# ENDL TEXAS

Date: 2 March 2006  
 To: T10 Technical Committee  
 From: Ralph O. Weber  
 Subject: SAS-2 Zoning - Phy Features

Figure n1 — Example of a ZPSDS with the ZONE ADDRESS RESOLVED bit set to zero

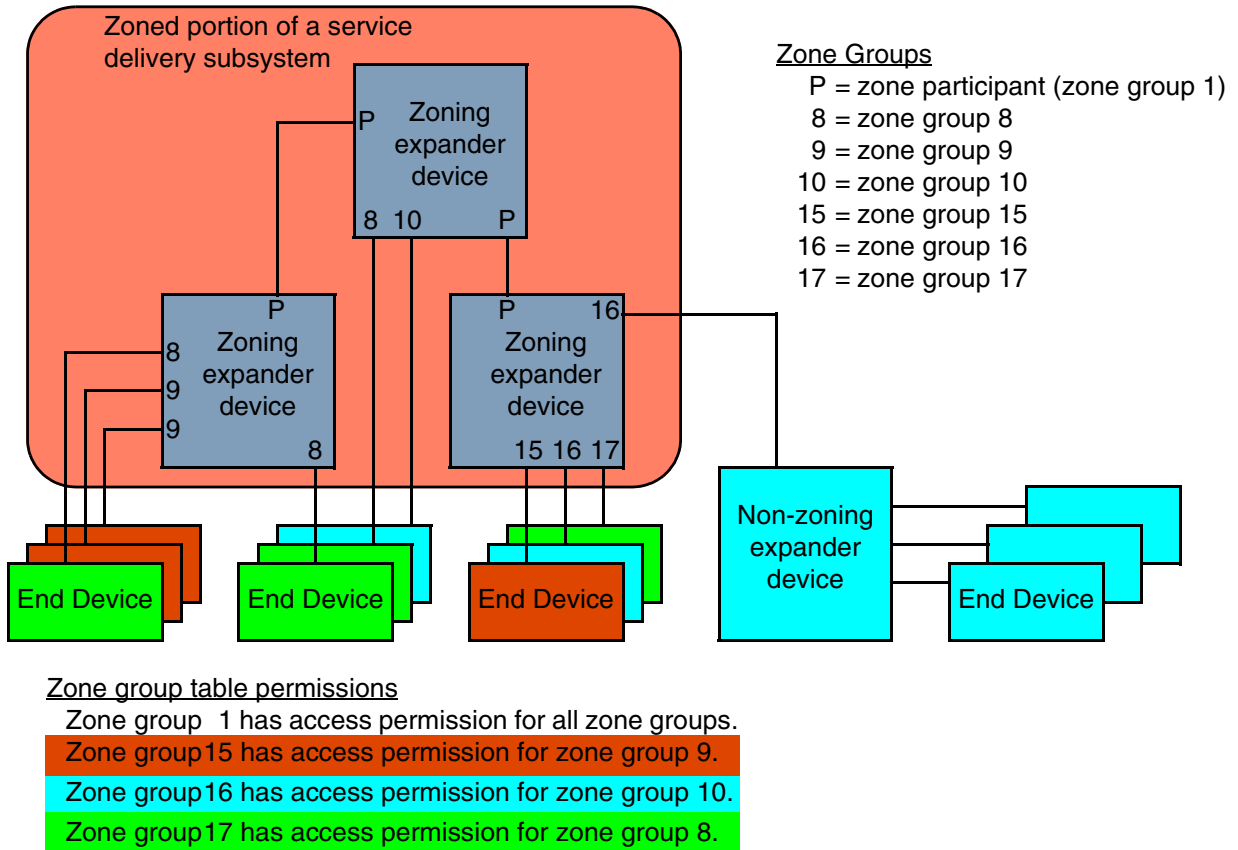
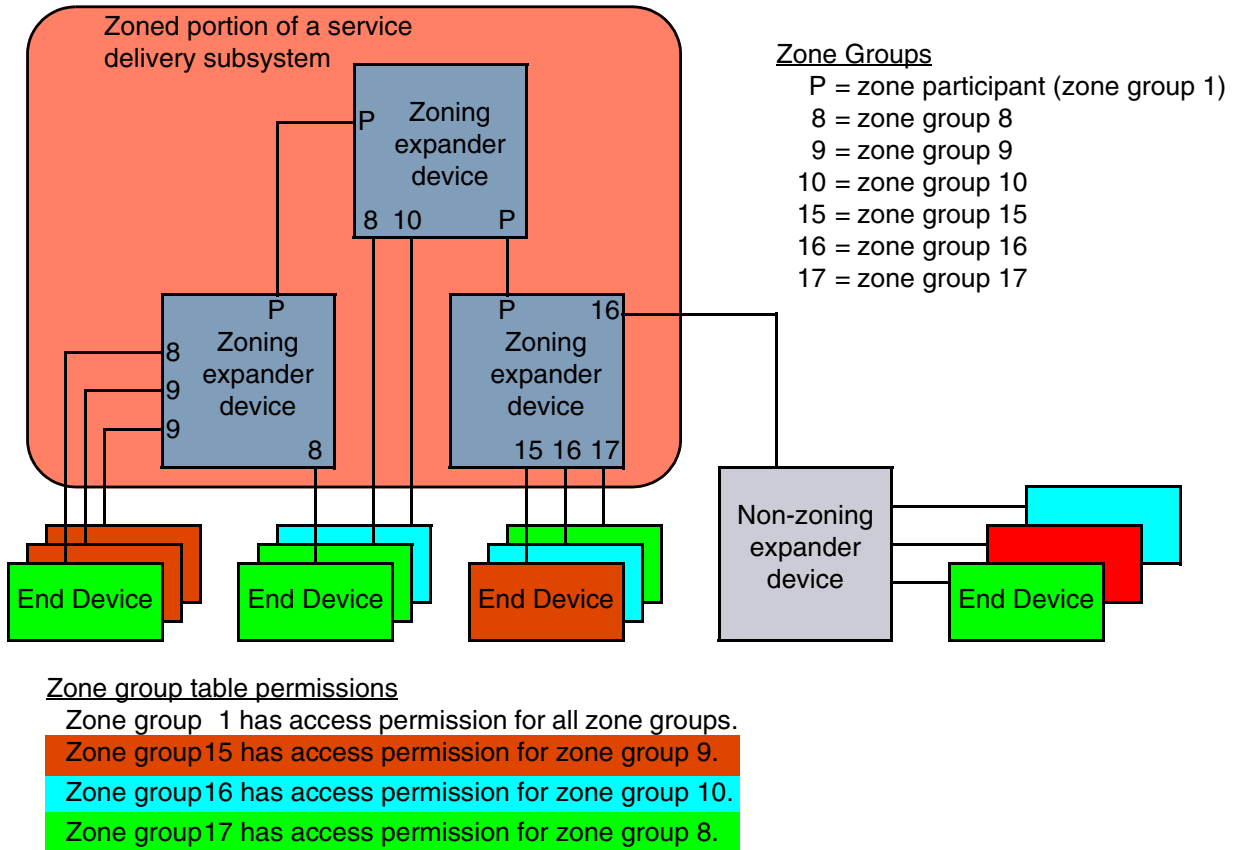
Figure n1 shows an example of a ZPSDS in which the zoning expander devices all have the ZONE ADDRESS RESOLVED bit set to zero.

Figure n3 — Zoning expander route table example

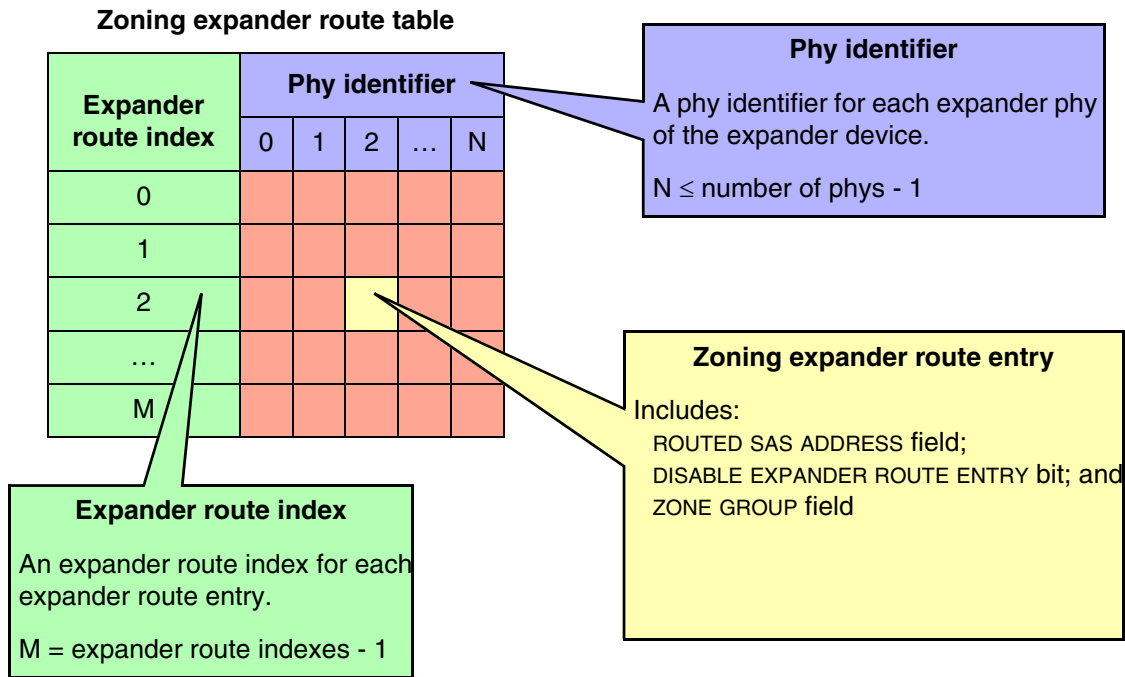
The zone route table in a zoning expander device shall contain zone phy information in addition to the expander phy information.

Figure 2 shows a representation of a zoning expander route table.
